ZONING CHANGE REVIEW SHEET

CASE: C814-2023-0027 (311-315 South Congress PUD)

ADDRESS: 311, 313, and 315 South Congress Avenue

TO: PUD-NP

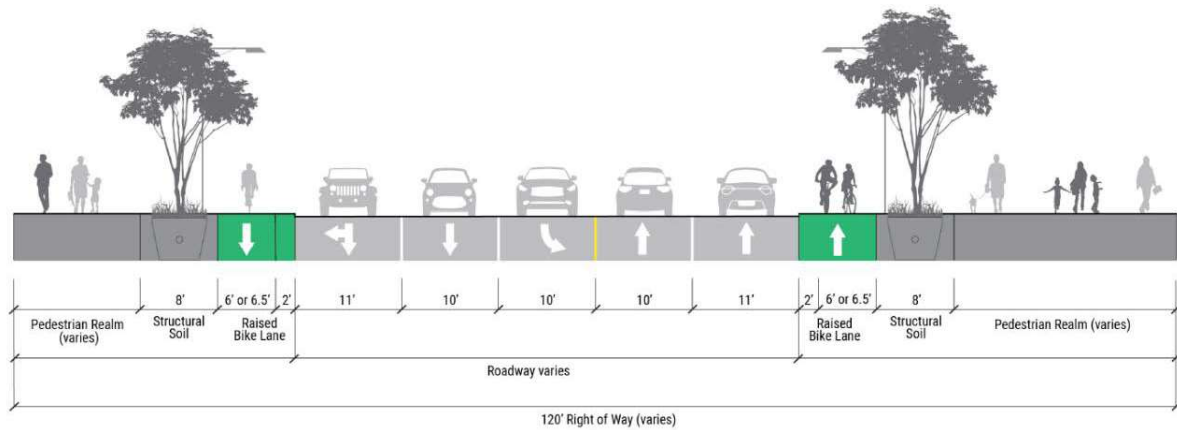
ATD 7. ATD does not recommend approval of this proposed language of Land Use Plan note #8 (noted above). To provide superiority for the streetscape, we request that the site adhere to the streetscape standards as depicted within the proposed in the South Central Waterfront Plan:

S. Congress: The South Central Waterfront plan calls for a 6’-6.5’ raised bike lane behind a 2’ buffer along the east frontage of S. Congress. The ASMP identifies protected bicycle facility along Congress frontage as well. In order to meet the superior results expected from PUDs, the cross sections should at least meet the baseline set by ASMP.

U1: Comment cleared.

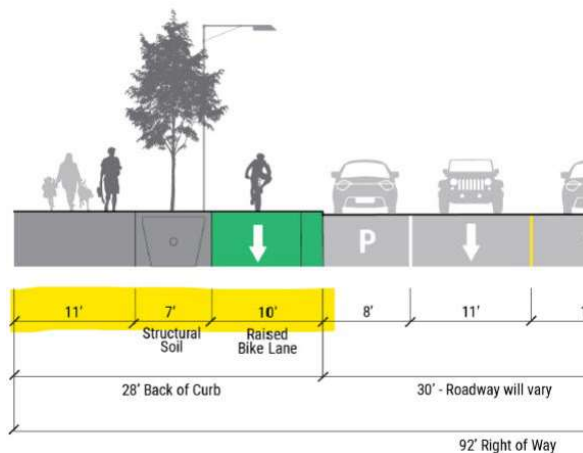
Barton Springs Road: The South-Central Waterfront plan calls for an 11' pedestrian zone and 8' planting zone, adjacent to an 8' raised bike lane behind a 2' buffer along the southwest frontage of the Barton Springs Road extension. In order to meet the superior results expected from PUDs, the site's frontage along the Barton Springs extension should provide these streetscape elements as depicted below:
